# Appendix K - Santos Fairview Water Release Scheme

Preliminary Document Public Comment Responses

18-Jul-2023  
EPBC 2021/8914 - Fairview Water Release Scheme

**Figure 3-1 S4 flow duration curve with water quality sampling event range**

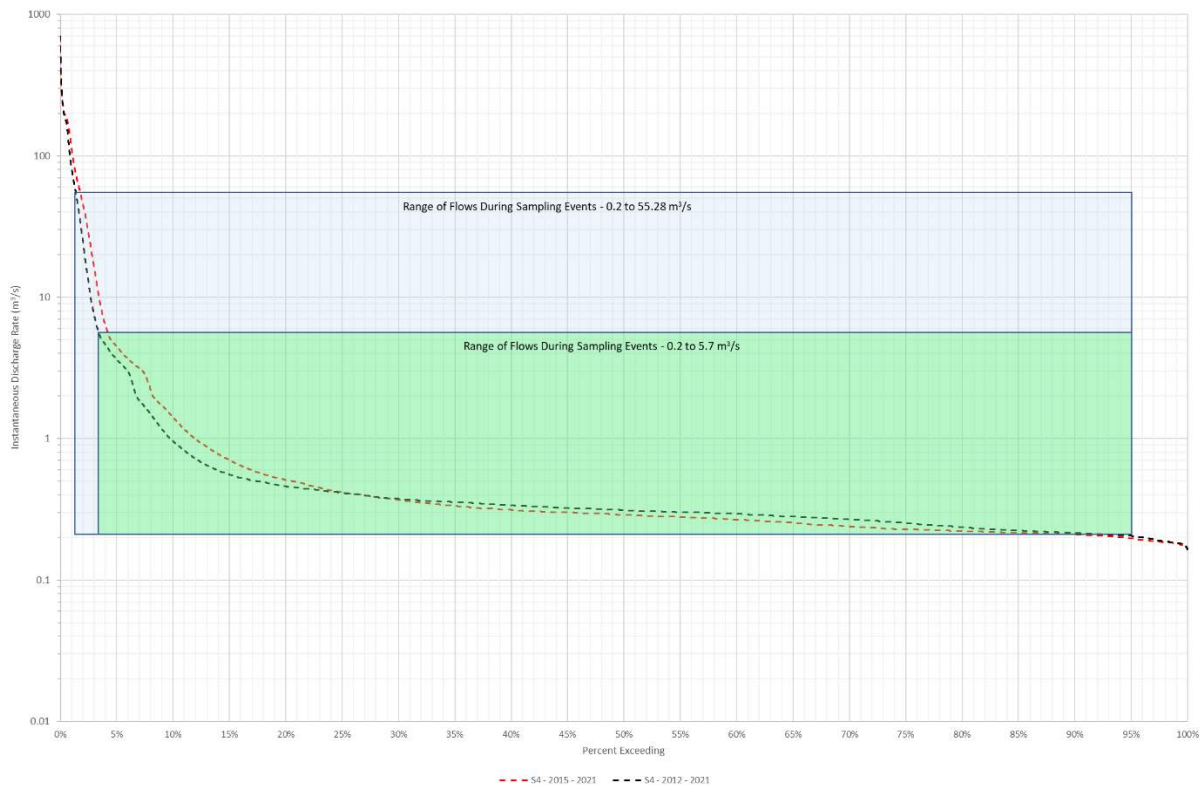
#### Comment 3.1 – River Flow

Water quality sampling at S4 has occurred over 115 sampling events between October 2009 and October 2022 as indicated Response 2.1, Table 2-1. 67 of the sampling events had concurrent flow data from S4 with the remainder missing due to either flood damage or prior to installation in October 2012.

The maximum flow rate during a water quality sampling event was 55.28 m<sup>3</sup>/s (2.9m flow depth). Conducting sampling under higher or flood flows is considered to represent a significant safety risk to sampling personnel and or equipment due to higher flow velocity and risks from debris within flood waters. Desalinated water releases during flood conditions would increase water levels by 0.01 m in Dawson River flows as discussed in Section 5.2.2.3.3 and Table 5-7 of the Fairview WRS PD and compared to the natural increase is considered de minimus and further empirical data would not change the outcome of the assessment undertaken.

**Figure 3-2 Boron concentrations in downstream assessment locations DRMP1 and S4**

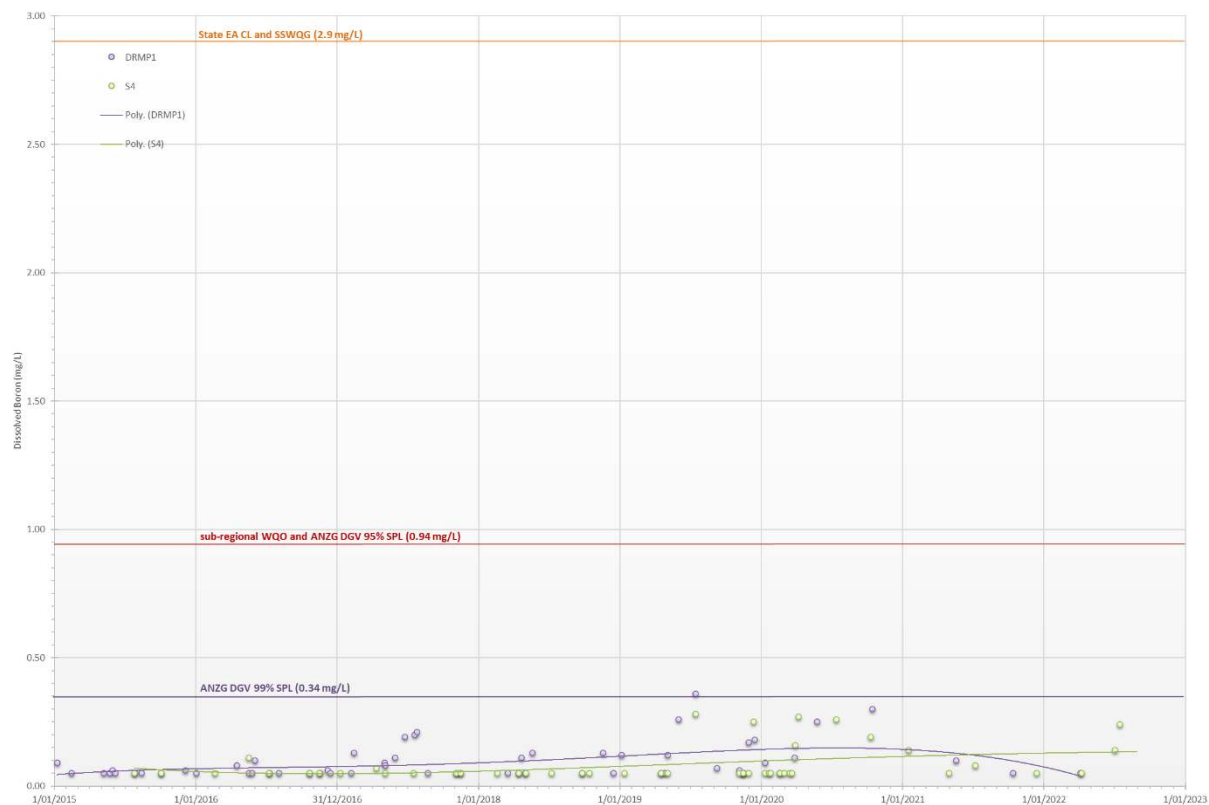
## Comment 3.2 – Boron

Refer to Response 2.1 for details of the number of water quality and biological sampling events and data for Dawson River water at DRMP1 and S4 downstream of the outlet watercourse.

Regarding the use of boron as an insecticide, US EPA guidance notes that boron's *"...low toxicity, and natural presence in terrestrial and aquatic environments are mitigating factors for any potential risk to non-target organisms"* ([USEPA, 1993](#)). While boron-based pesticides induce toxicity in terrestrial insects through direct exposures to high concentrations ([Gentz and Grace, 2006](#)), boron levels measured in the waterhole and Dawson River under the REMP and water quality monitoring program are demonstrably non-harmful (with most detections occurring beneath State EA and ANZG levels of concern).

Finally, the input of boron into the Dawson River system from surrounding agricultural land uses cannot be discounted. Cropping occurs on the floodplain adjacent to the waterhole, and in proximity to the downstream reaches of the Dawson River. Grazing and irrigation cropping occurs in the Dawson Valley, with irrigation occurring at Eurombah and Taroom. Boron is a known constituent of some agricultural fertilisers ([Incitec Pivot Fertilisers, 2022](#)) that may be used in the downstream region.

**Figure 4-1 Flow duration curve for Utopia Downs and S4 (Yebna Crossing)**

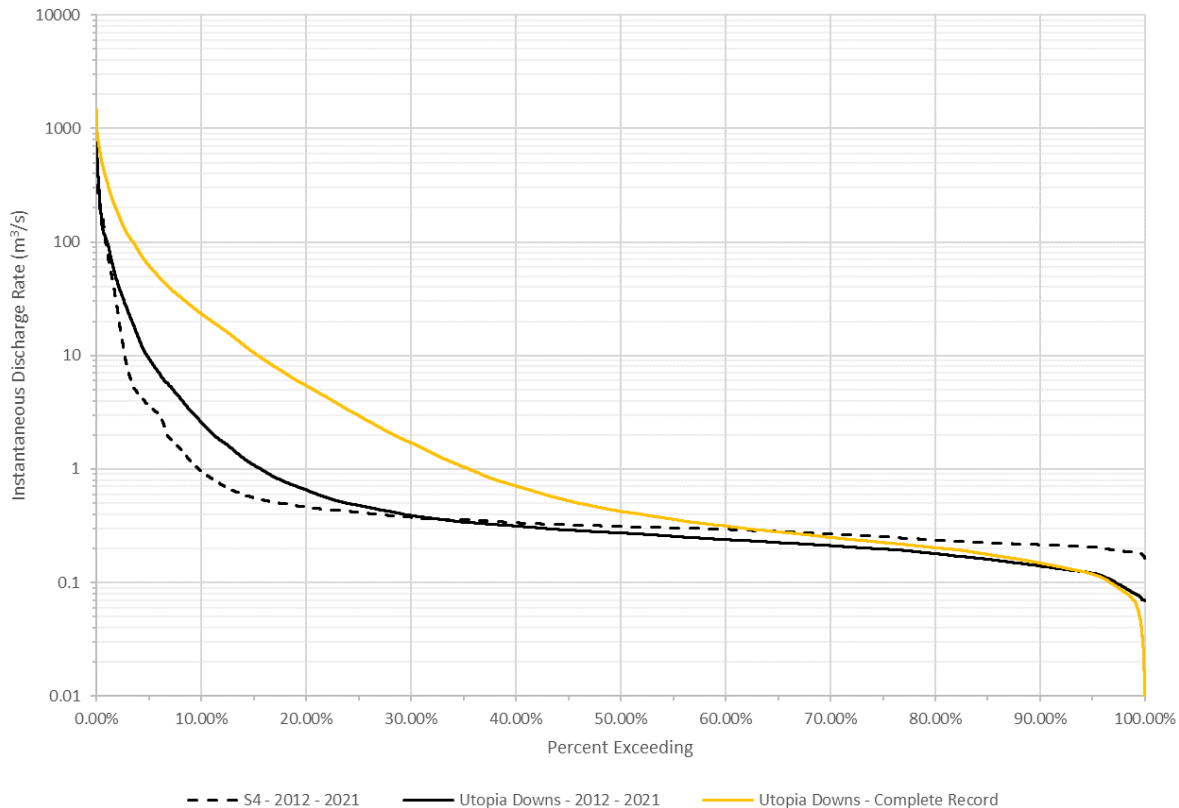
#### **Comment 4.1.1 – Flow regime and associated water quality characterisation**

Figure 4-1 below presents the flow duration curve for Utopia Downs (1966 – 2023), Utopia Downs (2012 to 2021) and S4 (2012 to 2021). The data comprise 30-minute flow data at the S4 gauge at Yebna Crossing and 60-minute flow data for the Utopia Downs gauge. The following conclusions are drawn from a comparison of the two sets of data over the 2012 to 2021 period (prior to the S4 gauge being destroyed in floods):

Jacobs (2019) estimated a baseflow rate of approx. 0.25 m<sup>3</sup>/s (250 L/s) upstream of the proposed action area. This baseflow was attributed to spring inflows from the Precipice Sandstone unit. This has been recorded at S4 (Yebna Crossing) over the 2012 to 2021 and compared to Utopia Downs over the same period in Figure 4-1. The Dawson River flow at both S4 and Utopia Downs is best characterised as perennial.

In conclusion, 56 years of gauging data from Utopia downs show that there are less than 0.1% of periods of no river flow. From 10 years of gauging data at S4 (Yebna Crossing), incorporating some low rainfall periods, no nil flow periods were observed.

*(Figure 5 – Flow duration curve for Dawson River (Wardingarri) at Utopia Downs, with daily treated water release rate indicated (orange line). The release rate exceeds natural river discharge monitored at this point approximately 40% of the time.)*

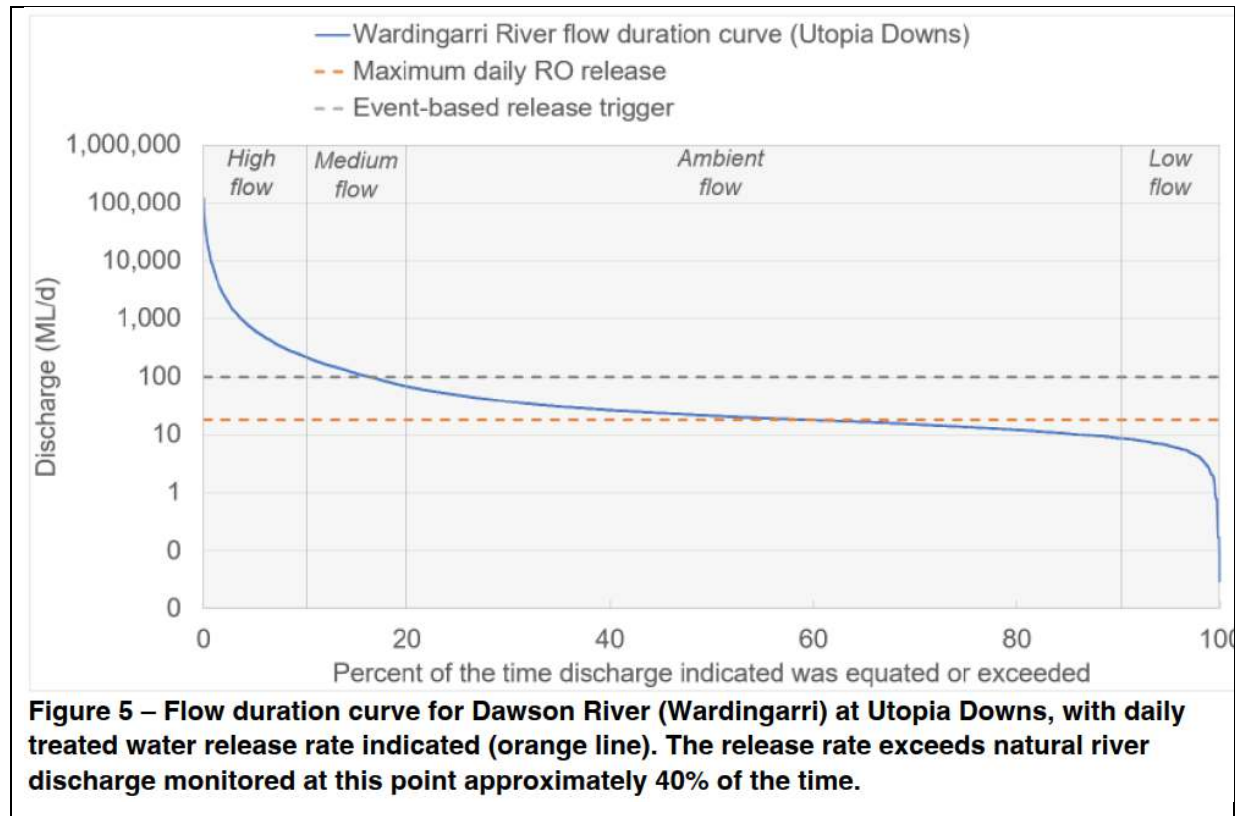
*Daily discharge of 18 ML/day will significantly reduce the magnitude and duration of low-flow spells in the Dawson River – Figure 5 shows a comparison of this discharge rate with the flow duration curve for Utopia Downs, approximately 60 km downstream of the releases.*

Comparison of the gauge data at S4 and Utopia Downs (refer Figure 4-1) suggests:

- For 2015 to 2021, the average daily rate of flow at Utopia Downs was 0.02 m<sup>3</sup>/s less than at S4
- The low flow portion of the flow exceedance curve is trending in opposite directions for each location. Between the 2012 to 2014 period and 2015 – 2021 period, low flows at S4 decreased in overall magnitude, whereas flows at Utopia Downs increased.

Figure 4-5 Revised conceptual groundwater model for the waterhole and Dawson River

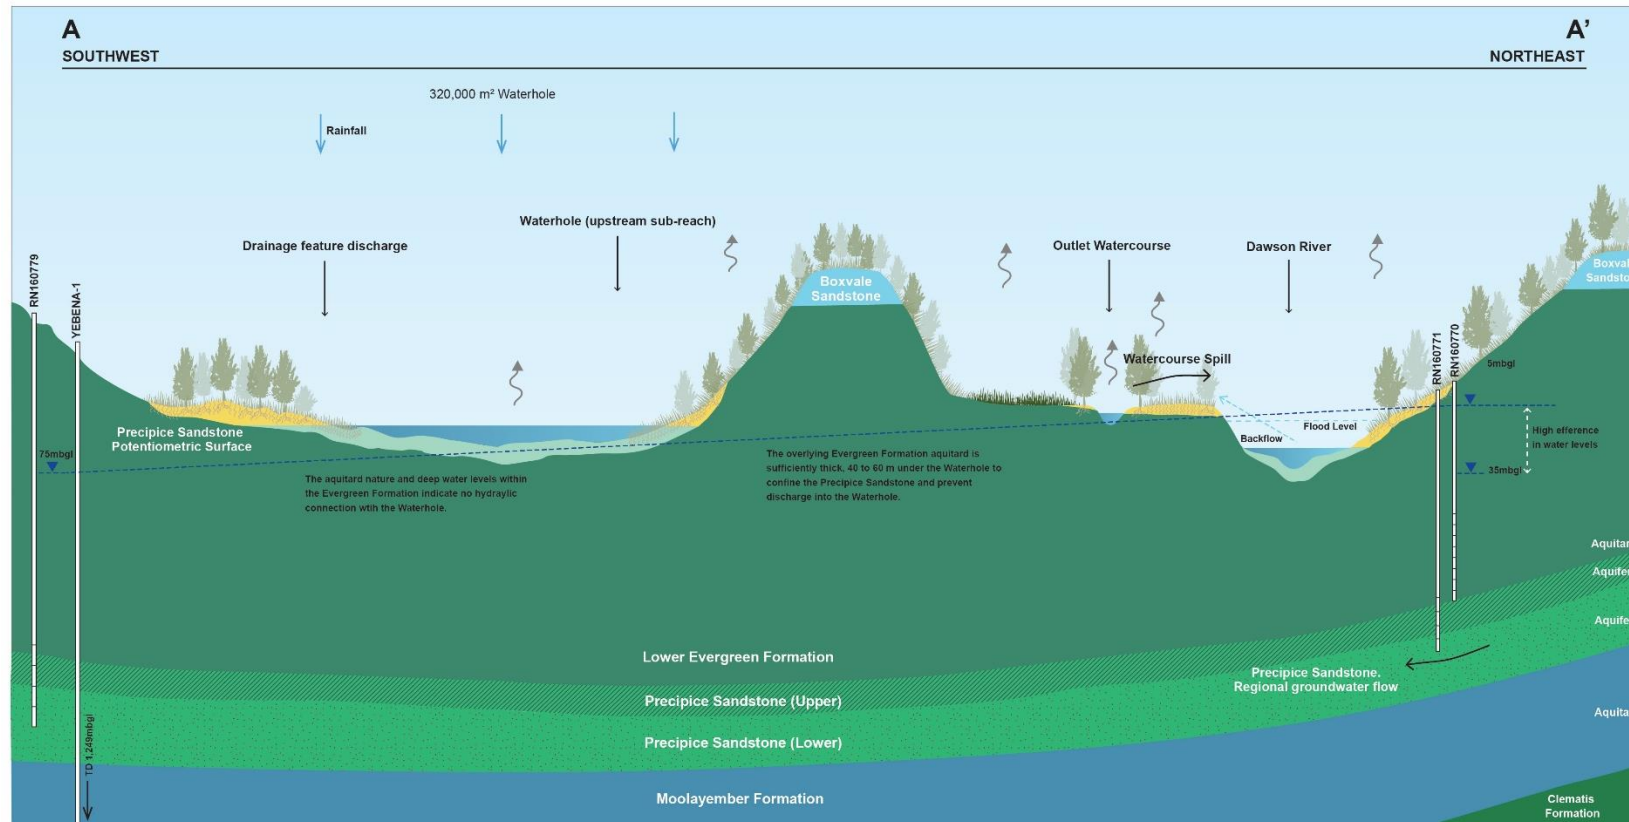
*Data from bore RN160770, screened in the upper Evergreen Formation near the Dawson River, shows rapid, periodic increases in level that decline gradually between rainfall events. (Figure 6 – Hydrograph of Evergreen Formation; a) bore location with respect to oxbow lake and Dawson River, b) groundwater level (m AHD) over time. Data from Queensland Globe)*

Based on the reported geology in Figure 4-3, the waterhole conceptual groundwater model was updated in Figure 4-5 below to indicate the location of the overlying Boxvale Sandstone more clearly in the vicinity of the waterhole. The Boxvale Sandstone is a member of the Evergreen Formation, which is younger than the underlying lower Evergreen Formation aquitard.

- There is no potential artificial recharge from the waterhole alluvium into the Boxvale Sandstone due to no hydraulic connection, refer to the revised hydrogeological conceptual cross section shown in Figure 4-5.

**Figure 1: Example of format for presenting water quality data along with flow conditions (indicated in yellow on flow duration curve) to characterise flow/quality relationships (Nicholson et al., 2022).**

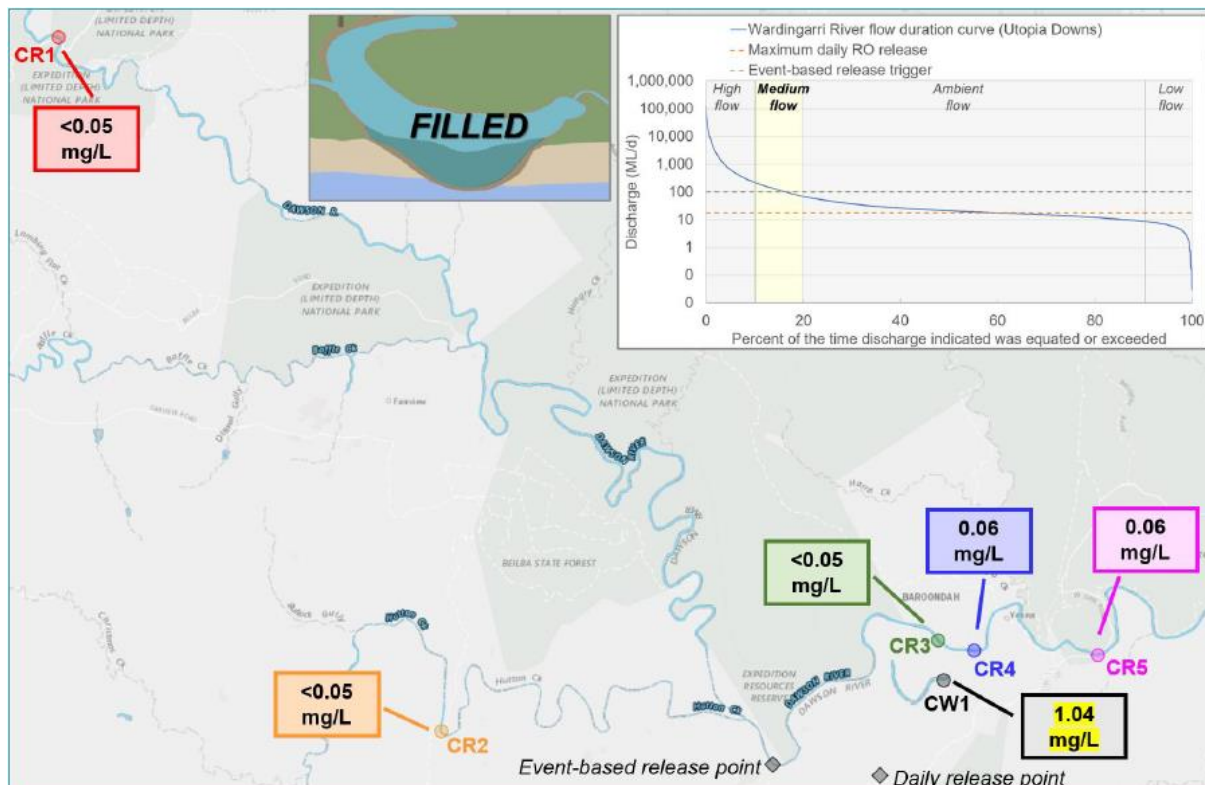
In order to understand how water quality in the Dawson will be affected by the releases through different periods of time, sampling of baseline water quality data and reporting of ongoing water quality results should occur during minimum (baseflow), low flow, moderate, medium, and high flow conditions, each at multiple upstream and downstream sites where sensitive species such as the threatened turtles may inhabit, and each on multiple occasions to give statistical robustness to the results. An example of how water quality data can be reported together with information on flow conditions is presented below:

Such analysis is vital for a thorough assessment of the likely impact of the additional treated water discharges into a highly variable river environment.

**Figure 2: Comparison of (a) Oxbow Lake Wetland and (b) Hutton Creek site (DRR2) during 2022**

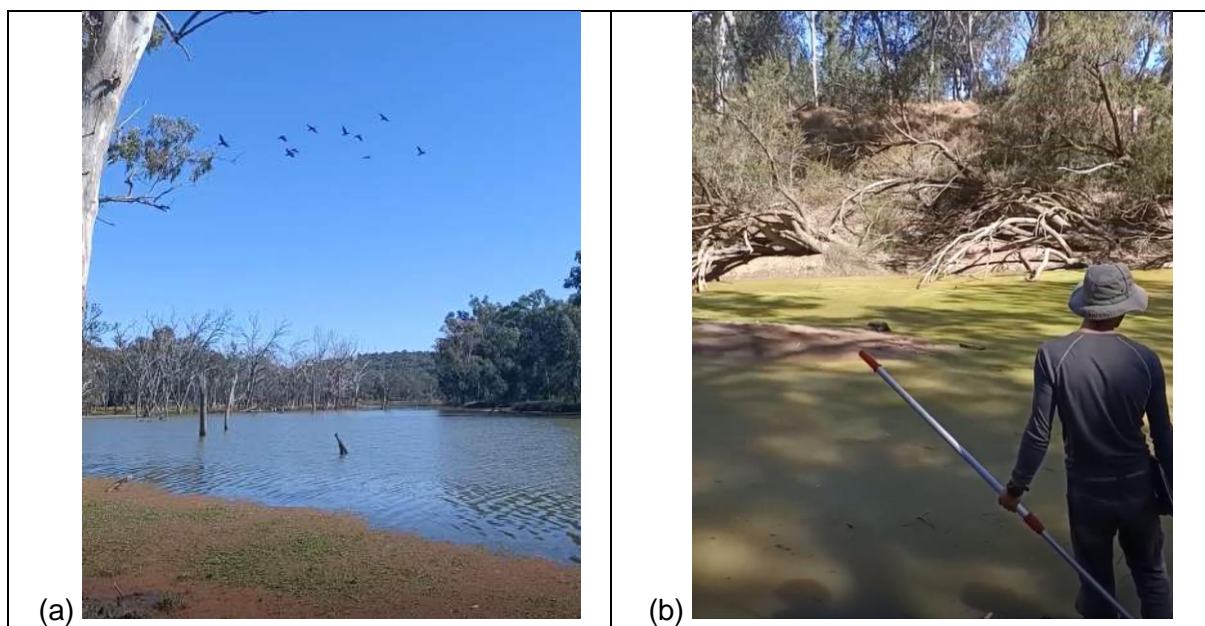
It is also questionable whether the use of DRR2 as a control site is appropriate, as it appears to be influenced by disturbance from nearby irrigation schemes (Figure 2). The RMIT team visited the DRR2 site during fieldwork in 2022, and found elevated levels of turbidity, total iron and aluminium in the water, along with an algal sheen on the surface of the water body (Figure 2 and Table 1). The environment was very different – both qualitatively and quantitatively – to the oxbow lake wetland for which it is serving as a control site, meaning it may not be an adequate indicator of the effects of the releases on this environment.

**Figure 3: Location of control site for oxbow wetland (Hutton Creek), showing locations irrigation schemes utilising co-produced CSG water (Nicholson et al., 2022). Site is labelled CR2 as per the nomenclature selected in the RMIT capstone research, but is the same site as DRR2**

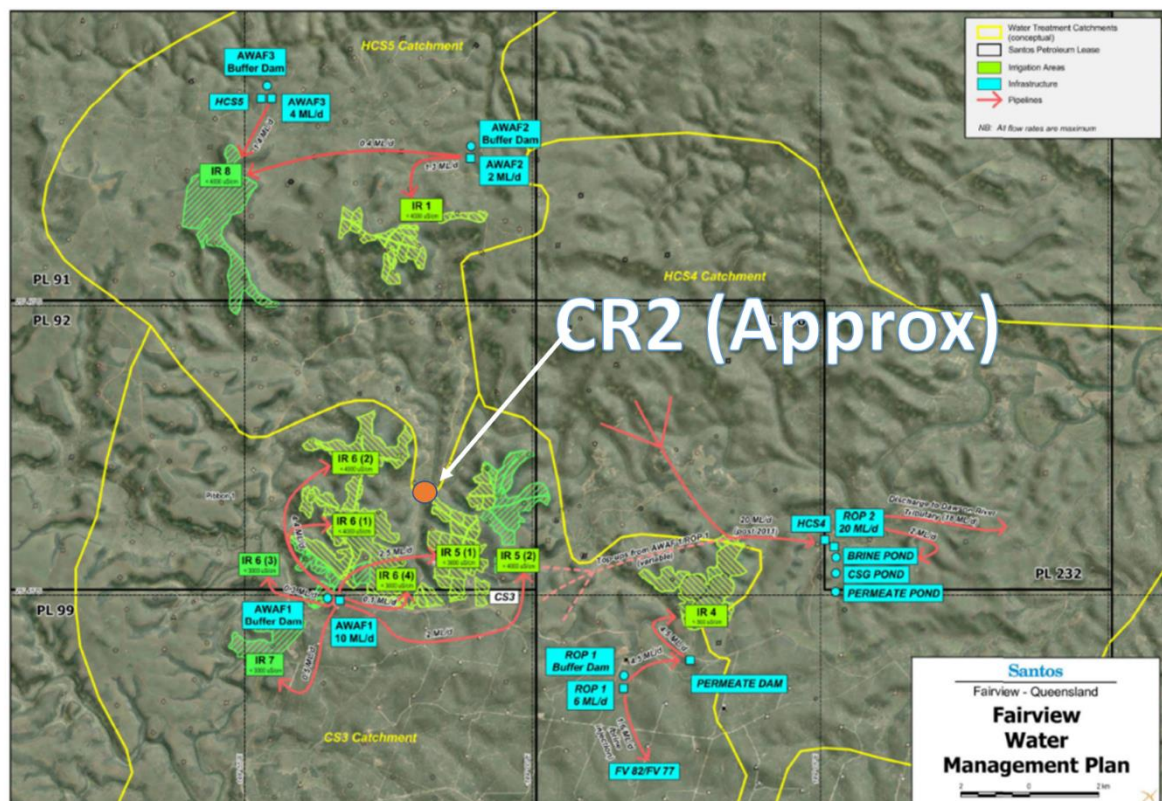
Water quality impacts observed at Hutton Creek were considered likely to be a result of runoff from the surrounding Santos irrigation schemes (shown in shaded green on Figure 3 below), which utilise treated and un-treated CSG wastewater (the site is labelled CR2 in Figure 3 below).

**Figure 4 – (a) Species-Specific Distribution utilised to derive the ANZECC default 95% guideline value of 0.94mg/L. (b) Species-Specific Distribution utilised to derive the site-specific guideline value of 2.9 mg/L for the Fairview release scheme (Adapted from: AECOM 2019, and ANZG 2021)**

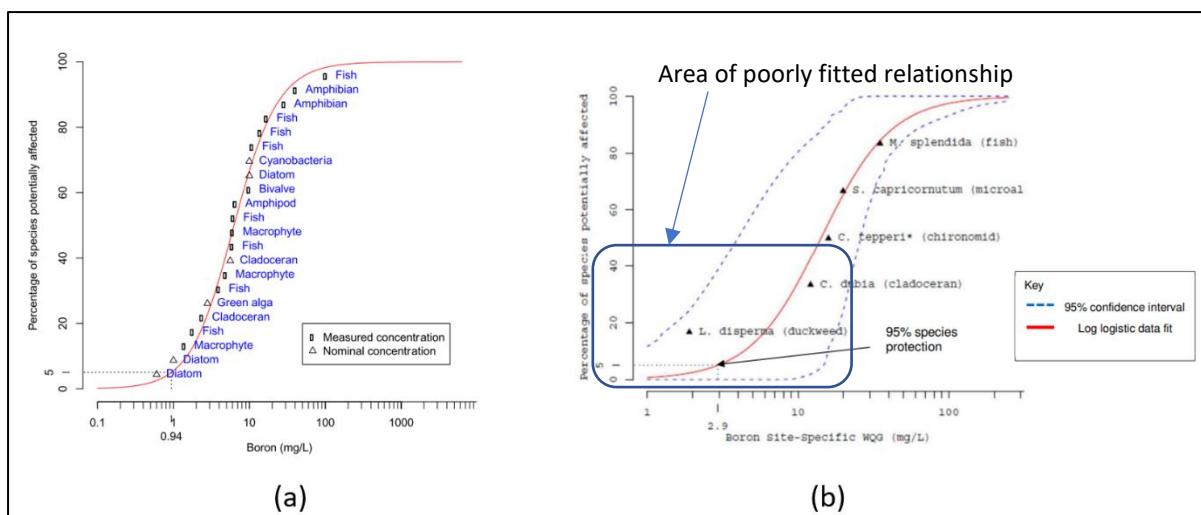
The impact of boron concentration increases on threatened species inhabiting the receiving environment – including considering water quality/flow relationships (section 1) remains poorly understood. Concentrations of Boron in the desalinated water and oxbow lake wetland frequently exceed ANZECC default guidelines for protection of 95% and 99% aquatic species (0.94 and 0.34 mg/L, respectively). Santos have negotiated with the Queensland regulator to amend the water quality objective for Boron in the receiving environment for the current approved treated releases, to 2.9 mg/L (as of 2022). This value was derived by plotting ecotoxicology test results estimating IC/EC10 (an indicator of chronic and acute effect concentrations), from five species to a log-logistic fit of concentration vs. %species protection level. The line of best fit achieved from the data is poor (see figure 4b) and there is particularly high uncertainty in the shape of fit at the low end of the response curve, which is critical for derivation of the 95 or 99% species protection value:

Warne et al. (2018, p. 19) note that the use of such a low number of species to derive a WQO is at the bare minimum of what is considered ‘adequate’; datasets with 8–14 species belonging to at least four taxonomic groups are considered ‘good’, and those that contain data for at least 15 species are ‘preferred’.
